MECHANICAL ADDENDUM

TO **x-design Inc.**
1135 Dundas Street East, Suite 200
Toronto, ON M4M 1R9 **ADD - M-01**

PROJECT 55 John Street - Metro Hall - Floor 11 - Toronto Public Health

SUBJECT Mechanical Addendum M-01

DRAWING
11TH FLOOR MECHANICAL PLAN: H.V.A.C. LAYOUT - DEMOLITION

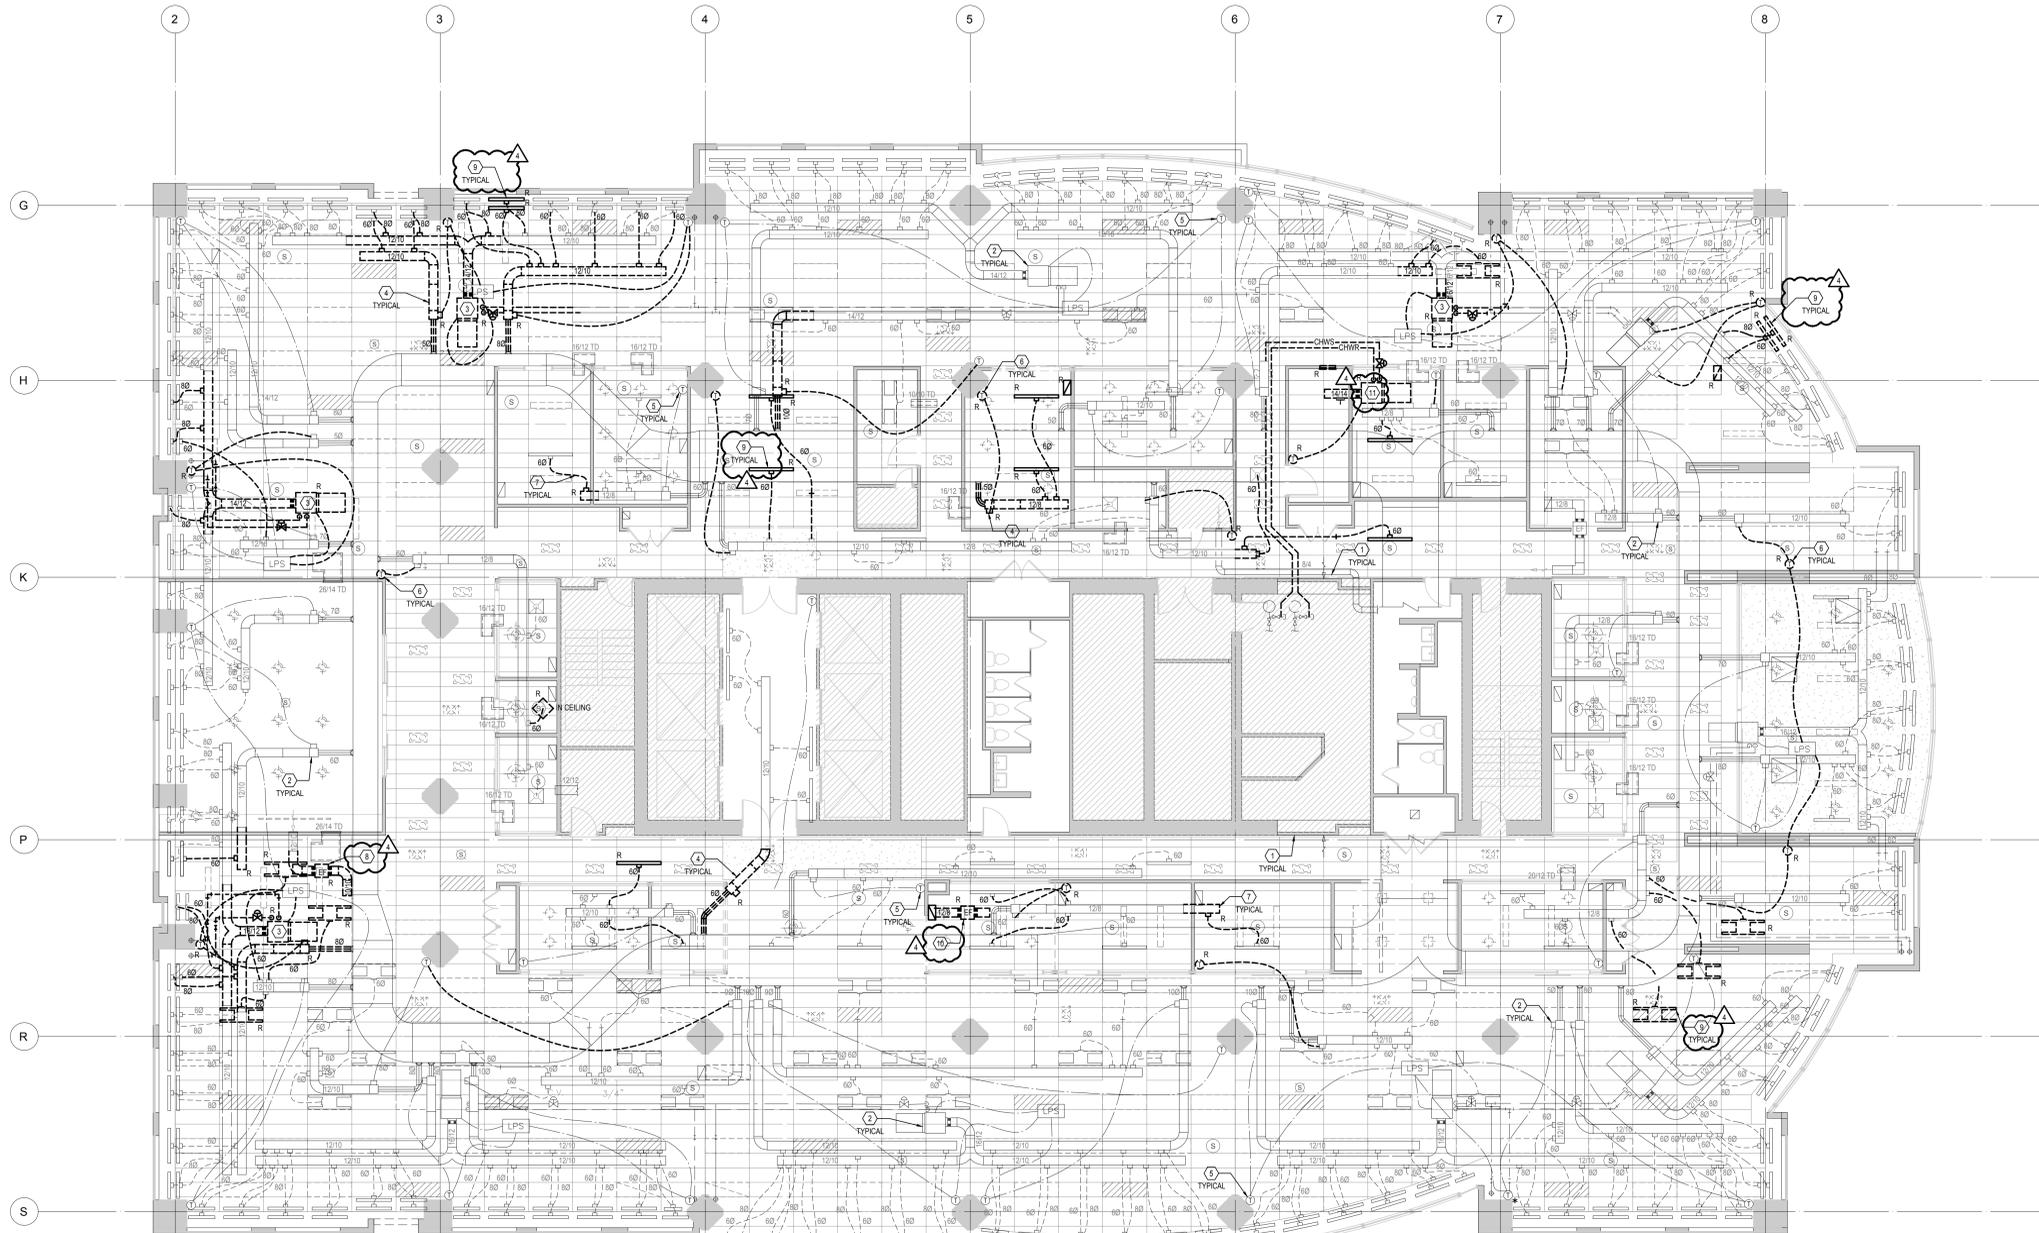
- 2.1 Drawing No. TM-11.1:
 - Added tags as shown.
 - Added keyed notes #8, 9, 10 and 11 as shown.
- 2.2 Drawing No. TM-11.2:
 - Added tags and duct sizes as shown.
 - Added keyed notes #10, 11, 12, 13, 14, 15, 16, 17, 18 and 19 as shown.
